RADIO CORPORATION OF AMERICA
RCA LABORATORIES
David Sarnoff Research Center
PRINCETON, N. J.

April 16, 1962

Mr. Herb S. Ellis
Paddock Pool Builders, Inc.
P.O. Box 5101
Albany 5, New York

Your drawing dated April 4 for the pool in Van Hornsville appears to conform with our discussion of the various points. There are some small changes I would like to make subject, of course, to your expert advice.

Proposed change
in beam - sides only.

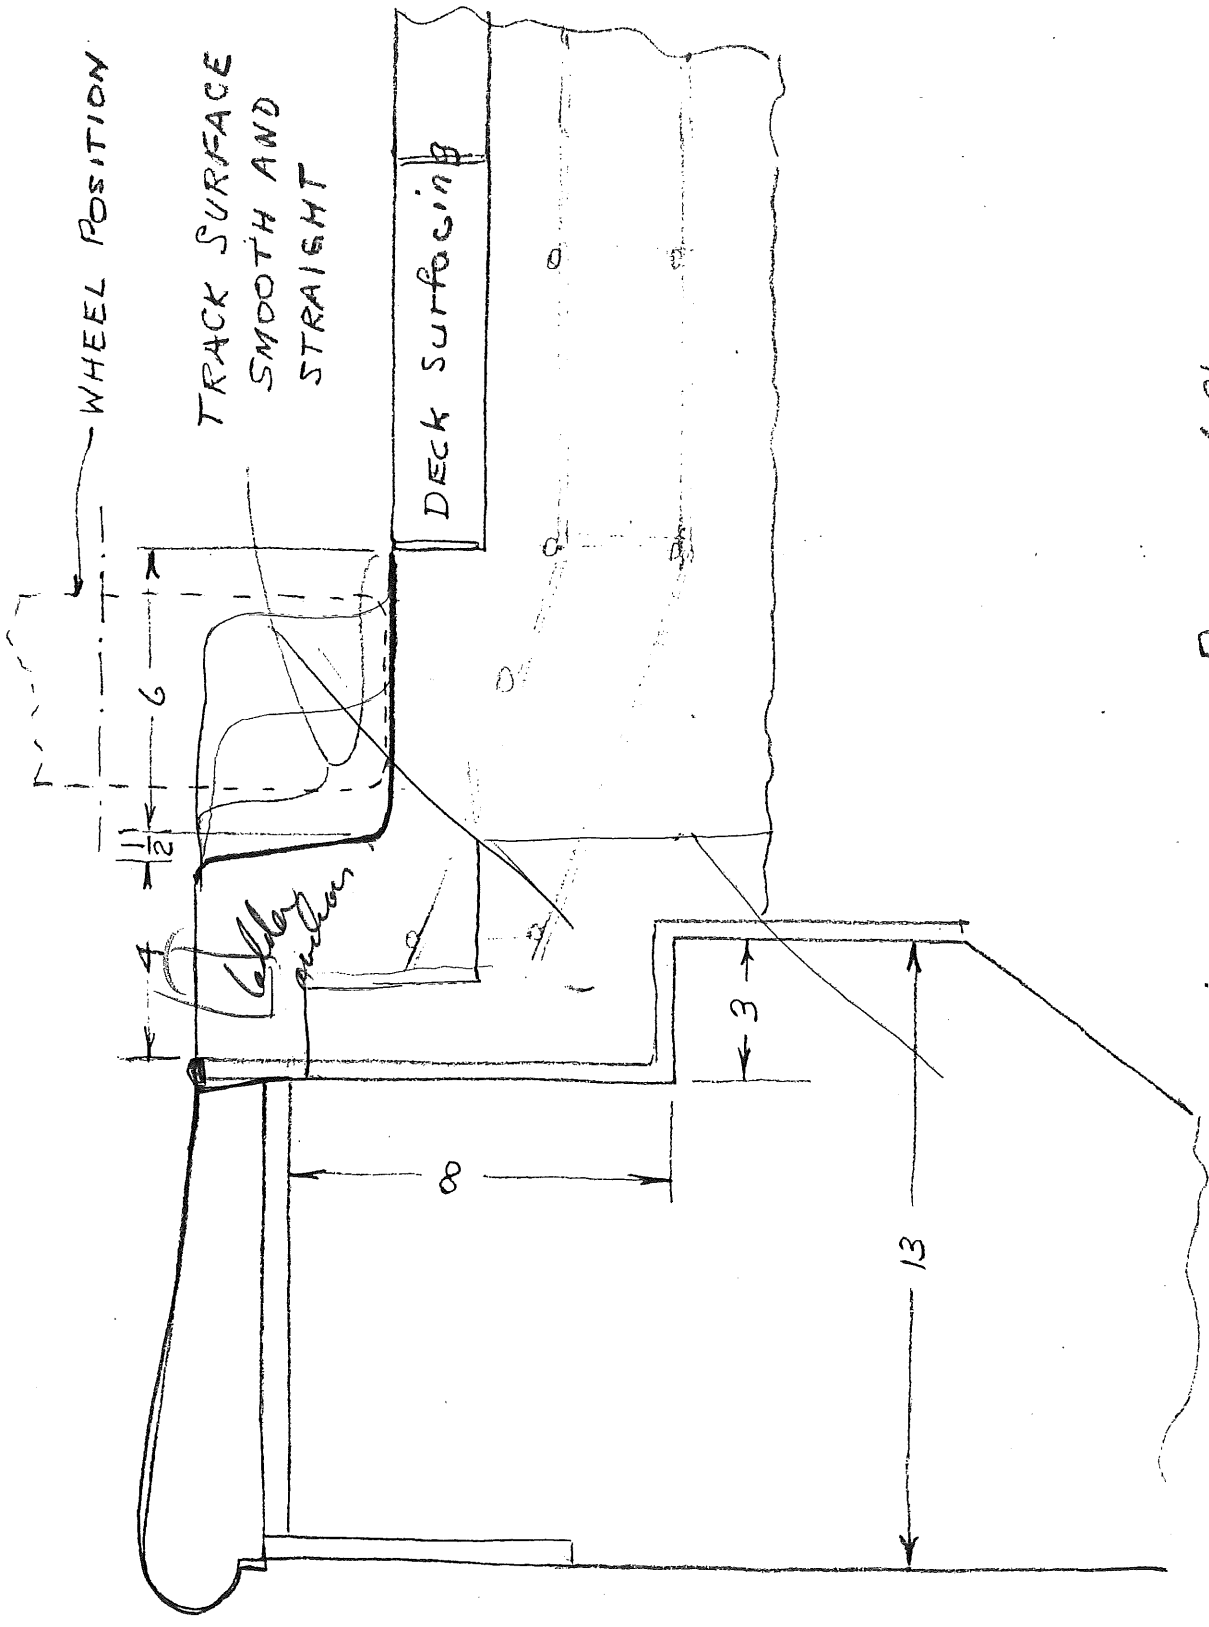
A concrete step on each side of the pool would provide both a load bearing surface and a guide. I enclose a sketch dated 4/15/62 showing a design which seems to me practical and not too clumsy in appearance. It calls for some changes in the shape of the pool beam from your drawing of 4/5/62. The load on each wheel (12 inches diameter and 3 or 4 inches wide) would not exceed 1000 lbs. The sill would be blocked up in winter so snow load would be distributed. I would appreciate your taking a critical look at the sketch and giving me your advice.

The sketch shows the step only 4 inches back of the coping, too close for mounting standard ladders. Unless you have some other suggestions, ~~the ladders should therefore be mounted on the springboard end of the pool~~ at the corners (see "Paddock of California" page 3).
